File No: R/2016/20/B  
Our Ref: 2017/621048

**Amended Concept Proposal for Cockle Bay Wharf (SSD 7684), 17-27 Wheat Road, Sydney**

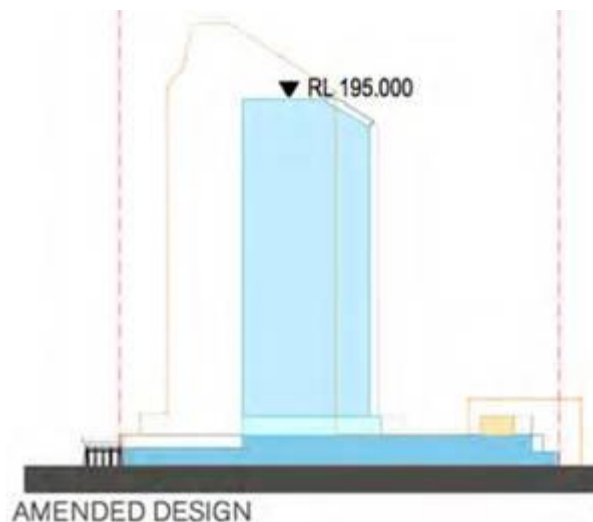
In considering the impacts of the Concept Proposal on Darling Harbour, the City has conducted a comparative analysis of overshadowing on 21 June that includes:

- the existing situation
- the Concept Proposal as currently proposed
- a modified Concept Proposal with a 12m tower setback to Darling Harbour (currently 8m. weighted average)
- a modified Concept Proposal with a 12m tower setback to Darling Harbour and an envelope reduced in height as shown in Attachment C (NB This reduced envelope equates to an approximate 15,000sqm reduction in GFA).

The analysis conducted by the City confirms that a 12 metre tower setback to Darling Harbour would eliminate overshadowing of the foreshore area to the development from 11am for the length of the site. It would also assist in providing built form relief to the density of the city. Appendix C of the Proponents EIS explores different massing options including a low rise options that would have significantly less overshadowing impacts on Future Town Hall Square and Darling Harbour than the Concept Proposal. Despite this, the low rise option was dismissed as it limited private 'view sharing' (from the Proponents other office towers). The site's surrounding context includes successful low to mid rise buildings including Darling Walk, the Novotel and the Convention Centre.
